SITE INSTRUCTION

PROJECT: HAMPTON MANOR
25 BAKER HILL BLVD
STOUFFVILLE, ONTARIO

SITE INSTRUCTION NO.: E-28

PURPOSE: Revise to suit site condition.

TITLE
**GROUND FLOOR PLAN - B
ELECTRICAL**

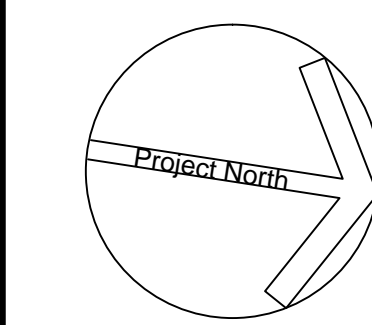
1.1 Remove: Enterphone at top of ramp as shown.
